## SERVICE LETTER 276

### Brake Torque Plate Safety Wire

<b>Aircraft Makes/Model(s):</b>	<b>Float Model(s):</b>	<b>Compliance:</b> Optional	<b>By:</b> MAS
DeHavilland DHC-2, DHC-3, DHC-6  Pilatus PC-6  Textron Aviation 208, 208B  Air Tractor AT-802, AT-802A	6000A, 6100A, 8000A, 8750A, 10000A, 13000A	<b>Part Number:</b> 1013053	<b>Approved:</b> DRH
		<b>Date:</b> 2/11/2026	<b>Revision:</b> A

**Figure 1 – Hardware for Safety Wire (Qtys shown are per Torque Plate)**

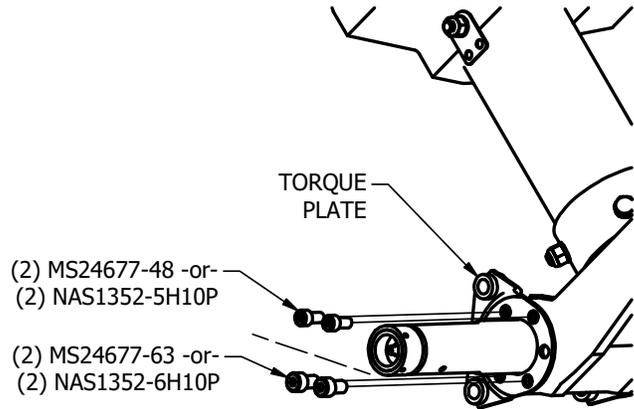
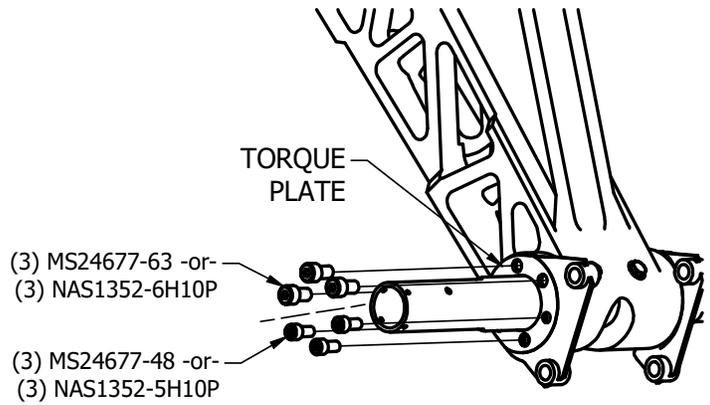
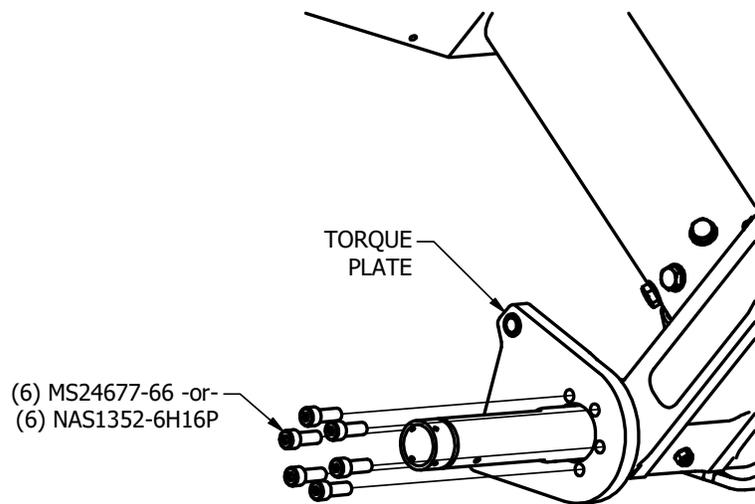
1. Position and prepare aircraft for safe maintenance.
2. Jack or hoist aircraft so that main landing gear wheels can be removed. Refer to associated float Service Manual.
3. Remove brake components and main landing gear wheels to access brake torque plate.
4. Remove and replace torque plate hardware as shown in Figure 1. Threadlocker is recommended (Loctite 242 or equivalent). Torque to:

5/16 screws: 150 in-lbs

3/8 screws: 190 in-lbs

**Figure 2 – Single-Wire Method, Six-Bolt Pattern**

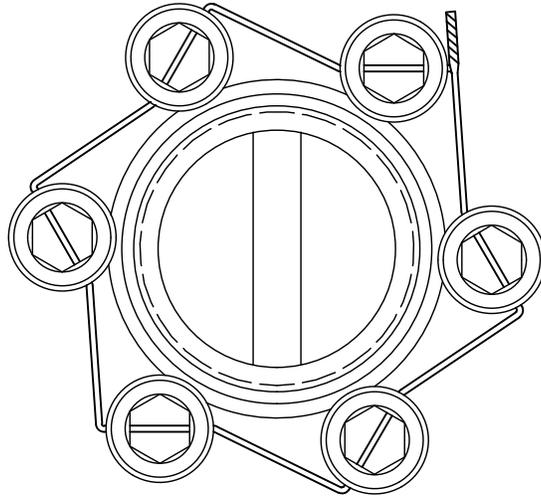
5. Safety wire with MS20995C32 in accordance with AC43.13-1B. Single-wire method is recommended for six-bolt patterns to ensure clearance with axle. Refer to Figure 2.
6. Reinstall brake and wheel components.
